Application for Mineral Mine Plan Revision or Amendment

Operator: <u>Kennecott Utah Copper</u>			
Mine Name: <u>Bingham Canyon Mine</u>		File Number: <u>M/035 / 002</u>	
Provide a detailed listing of all changes to the mining and reclamation plan that will be required as a result of this change. Individually list all maps and drawings that are to be added, replaced, or removed from the plan. Include changes of the table of contents, section of the plan, pages, or other information as needed to specifically locate, identify and revise or amend the existing Mining and Reclamation Plan. Include page, section and drawing numbers as part of the description.			
DETAILED SCHEDULE OF CHANGES TO THE MINING AND RECLAMATION PLAN			
			DESCRIPTION OF MAP, TEXT, OR MATERIALS TO BE CHANGED
<input type="checkbox"/> ADD	<input checked="" type="checkbox"/> REPLACE	<input type="checkbox"/> REMOVE	Figure 2-1 with Figure 2-1(R2) in the BCM 2003 Reclamation and Water Management Plan.

**INFORMATION FOR THE
BINGHAM CANYON MINE, HIGHLAND BOY DRAINAGE
GALLERY¹**

PERMIT M/035/002

STRATEGIC RESOURCES GROUP	KENNECOTT UTAH COPPER
SCALE:	FIGURE 2-1 (R2)
DRAWN BY:	MAP OF SURFACE FACILITIES
CHECKED BY:	IN THE VICINITY OF THE
ENGINEER:	BINGHAM CANYON MINE
Job No. ---	Dwg. No. ---
REV	REV

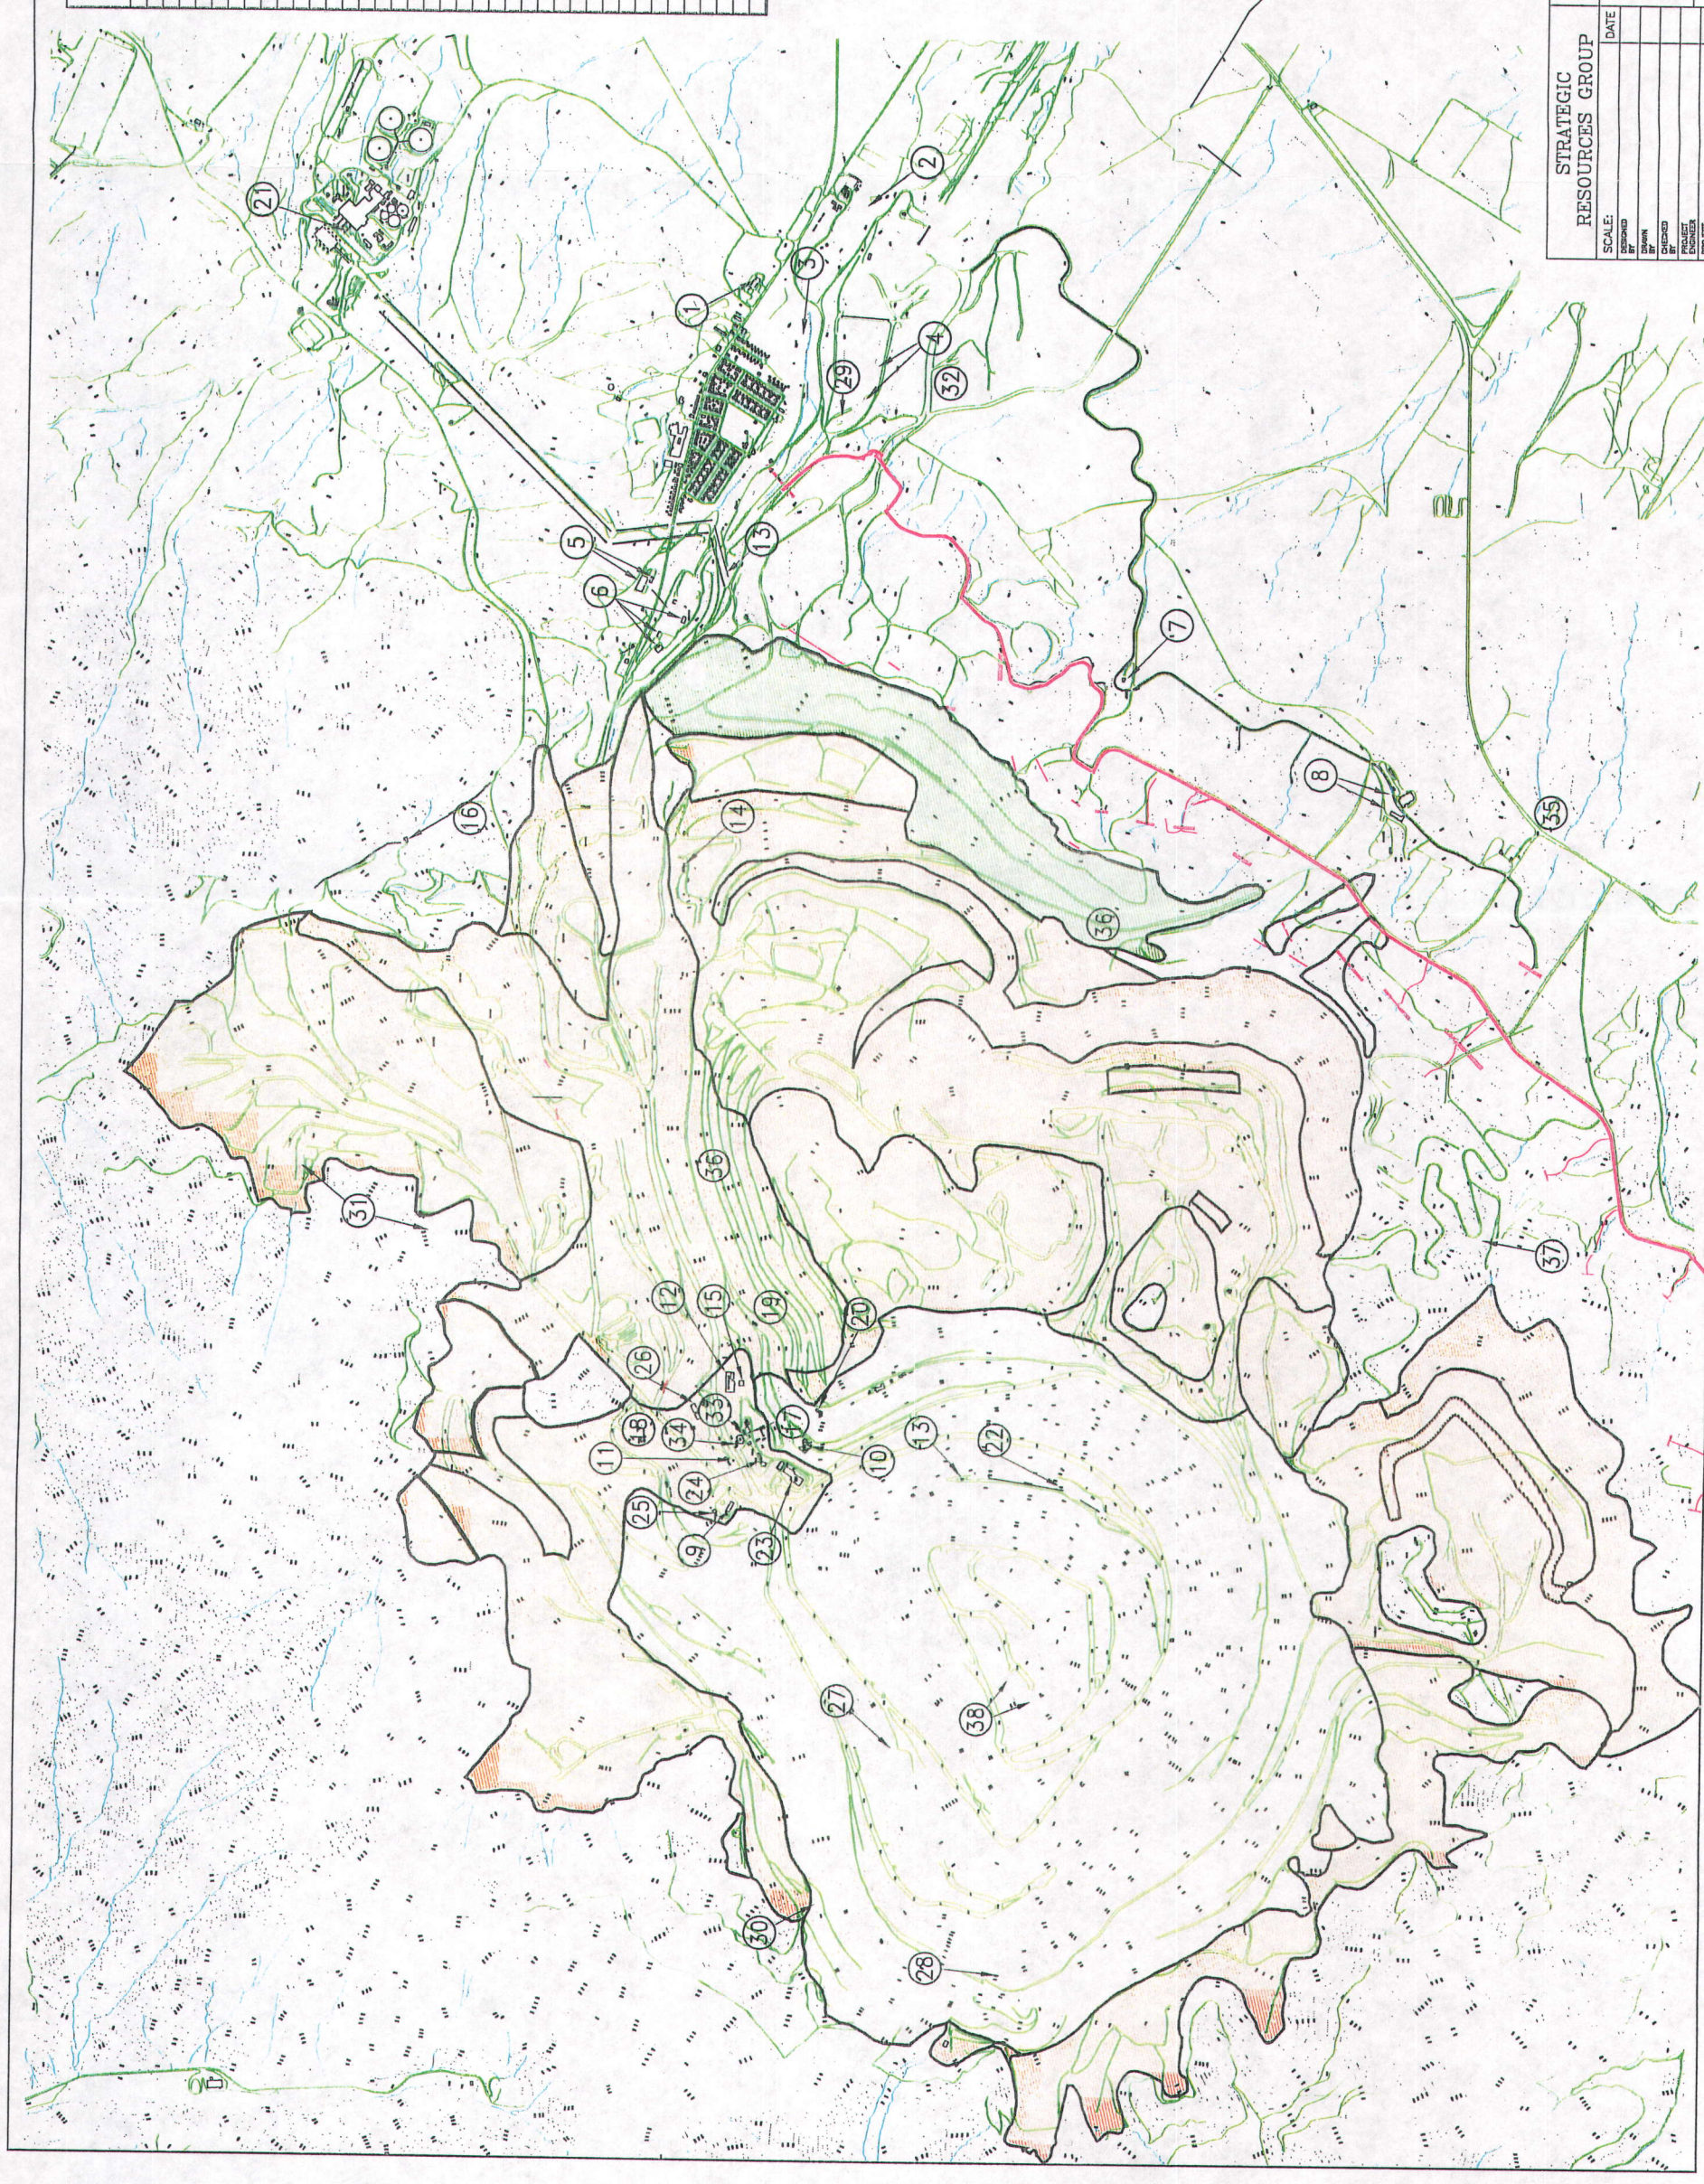
Figure 2-1 within the Bingham Canyon Mine 2003 Reclamation and Water Management Plan for DOGM permit M/035/002 is a map showing surface facilities in the vicinity of the Bingham Canyon Mine. Figure 2-1 has been updated (Figure 2-1 (R2)) with 2006 topography as well as current mine facilities at the 6190 foot elevation and the location of two surface portals for the Highland Boy Drainage Gallery (HBDG). Other than the portals and some minor ancillary facilities (i.e. substation), there will be no additional surface facilities or structures associated with the HBDG project. The approximate location of these facilities are depicted in the attached updated Figure 2-1 (R2), contained within Appendix 1.

Figure 2-1 (R2) has been updated to show the 2006 mine topography as well as current locations of mine facilities at the 6190 foot elevation. Figure 2-1(R2) also shows the location of two in-pit surface portals associated with the Highland Boy Drainage Gallery. KUC suggests that the attached Figure 2-1 (R2) replaces the existing Figure 2-1 within the Bingham Canyon Mine 2003 Mine Reclamation and Water Management Plan.

Figure 2-1 (R2) has been updated to show the 2006 mine topography as well as current locations of mine facilities at the 6190 foot elevation. Figure 2-1(R2) also shows the location of two in-pit surface portals associated with the Highland Boy Drainage Gallery. KUC suggests that the attached Figure 2-1 (R2) replaces the existing Figure 2-1 within the Bingham Canyon Mine 2003 Mine Reclamation and Water Management Plan.
